MIL ON With DTC(s) P1C5F19 and/or P1C5D19 Causing Over-current Condition

Service Category Vehicle Interior

Section Meter/Gauge/Display

Figure 1. View of Terminals at the Inverter

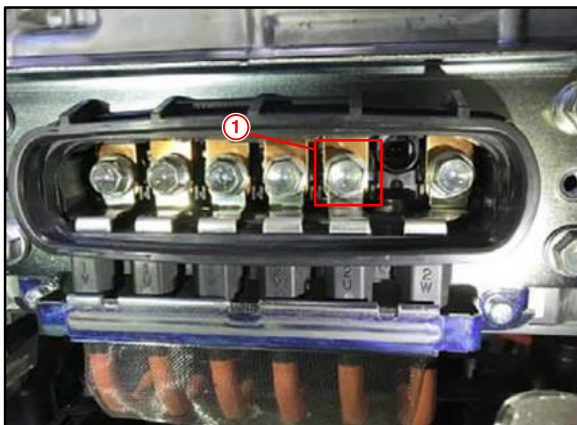
These conditions typically occur on low vehicle mileage (less than 5,000). After an occurrence, the vehicle will be able to run normally with no drivability issues. Follow the Repair Procedure in this bulletin to address these conditions.

1 Debris Created From Bolt Tightening

3. Using compressed air, blow out ALL potential debris on the terminals and connections area of the inverter and transaxle. Visually confirm there is no debris present on terminals and connections area.
4. Reinstall the MG cable with NEW bolts into the transaxle assembly. Inverter bolts can be reused. Refer to TIS, applicable model and model year Repair Manual:
 - 2019 – 2020 ES 300h:
Drivetrain – Hybrid Transmission/Transaxle – “[P710 \(Hybrid Transmission / Transaxle\): Motor Cable: Installation](#)”
 - 2019 – 2020 UX 250h:
Drivetrain – Hybrid Transmission/Transaxle – “[P711 \(Hybrid Transmission / Transaxle\): Motor Cable: Installation](#)”

Ensure correct fastening tools and torque are used when installing the MG cable. Over tightening can create additional debris.
